ADDENDUM NO. 2

TO: **All Prospective Bidders**
PROJECT: **Beach Access Road 1-B**
OWNER: **City of Port Aransas**
BID DATE: **Thursday, April 17, 2025 @ 11:00 AM**

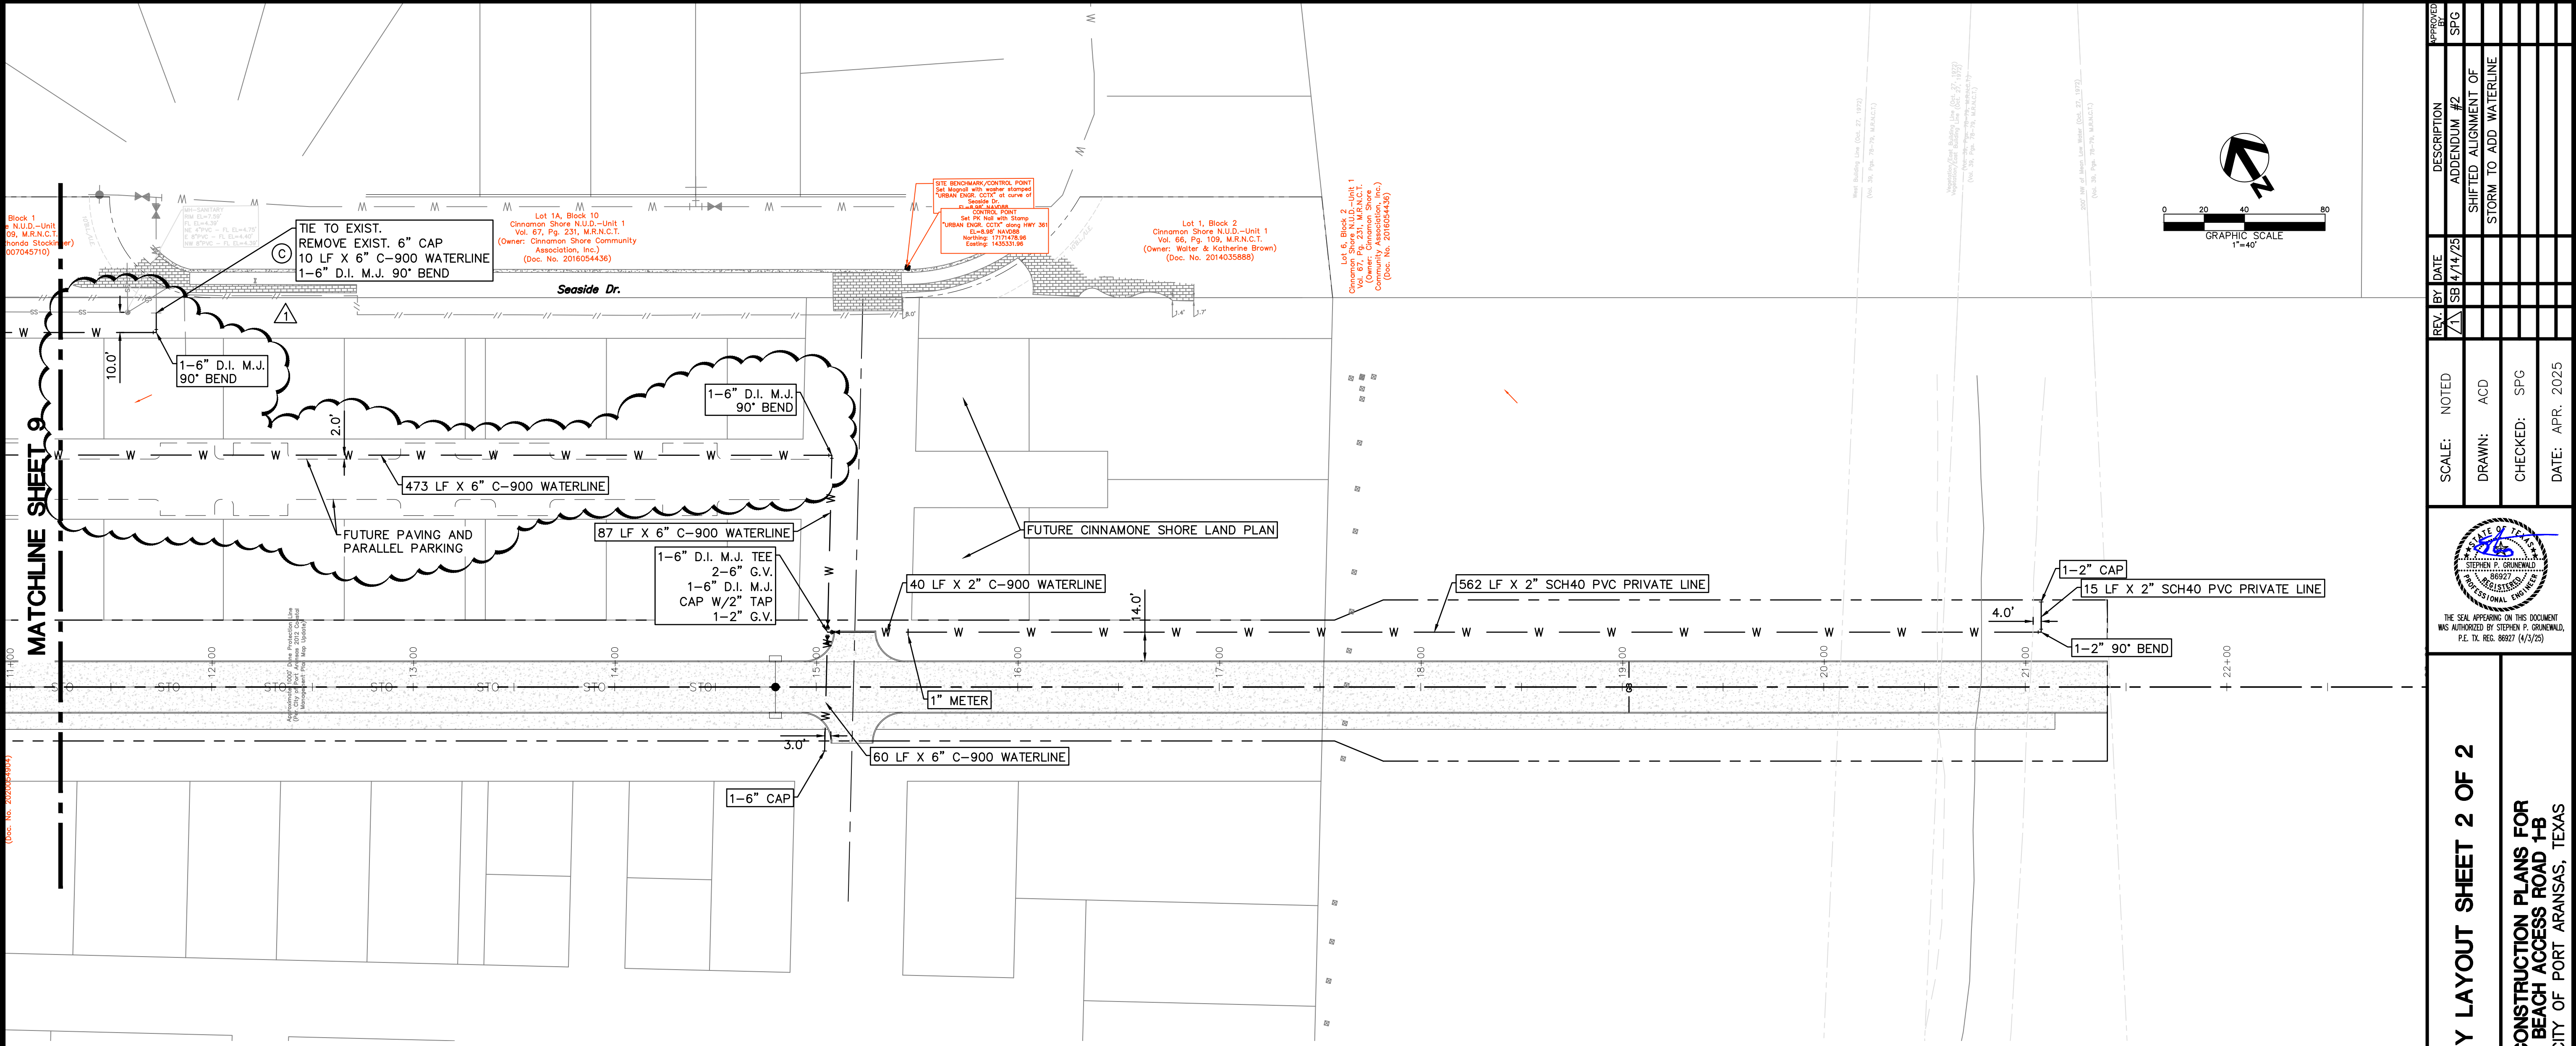
REV. BY	DATE	SCALE:	NOTED	DRAWN:	CHECKED:	DATE:	DESCRIPTION	ADDENDUM #2	SHIFTED ALIGNMENT OF	STORM TO ADD WATERLINE	SPG										
THE SEAL APPEARING ON THIS DOCUMENT WAS AUTHORIZED BY STEPHEN P. GRUNWALD, P.E. TX. RES. 88927 (4/3/25)								UTILITY LAYOUT SHEET 2 OF 2													
Urban DCCM								CONSTRUCTION PLANS FOR BEACH ACCESS ROAD 1-B CITY OF PORT ARANSAS, TEXAS													
Urban DCCM								SHEET 10 OF 18													
Urban DCCM								JOB NO. 02578
